Planning Commission Staff Report

April 13, 2016
Item 6.c.

- SUBJECT:** PUD-104-1M/PUD-81-22-15M
- APPLICANT:** Terrasset Management Group, on behalf of Workday, Inc.
- PROPERTY OWNERS:** NPC Holdings, LLC and San Francisco Bay Area Rapid Transit District (BART)

- PURPOSE:** Applications for Planned Unit Development Major Modifications to construct a six-story, approximately 410,000-square-foot office building, parking garage, and related site improvements instead of the previously-approved plans to construct a six-story, approximately 430,000-square-foot office building, two parking garages, and related site improvements.

Figure 3: Approved Site Plan

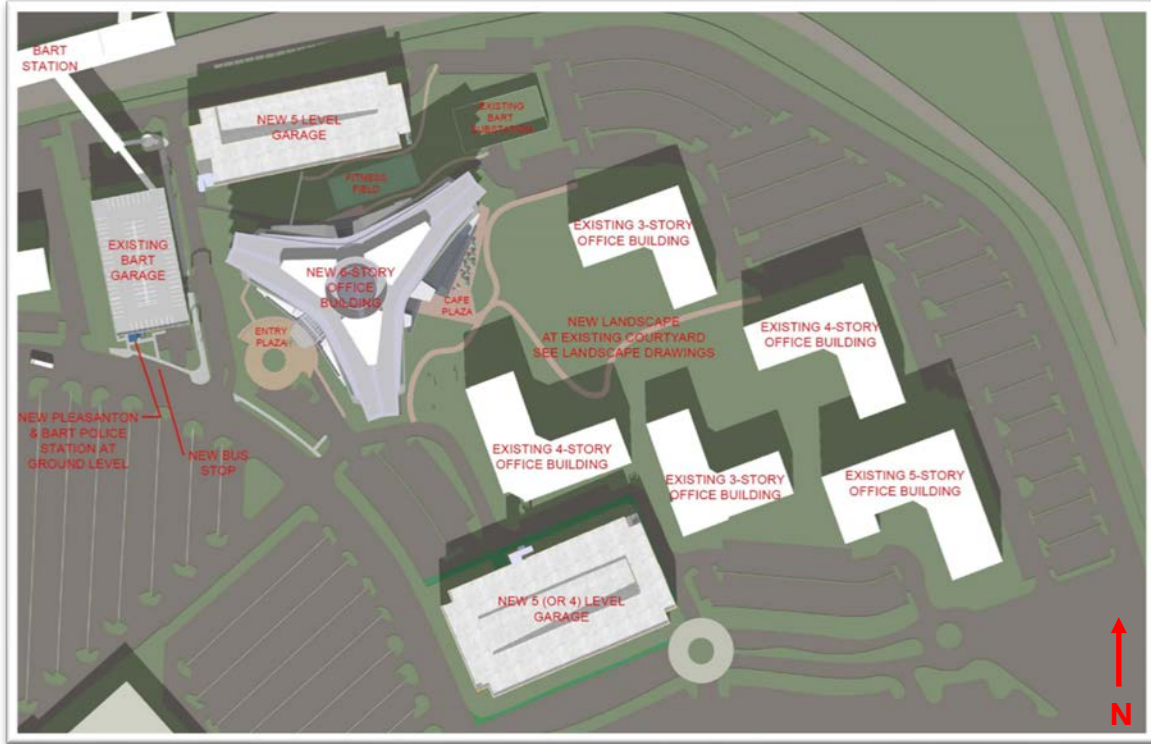
Additional differences between the plans are described in Table 1. Figures 3 and 4 also show the approved and proposed site plans.
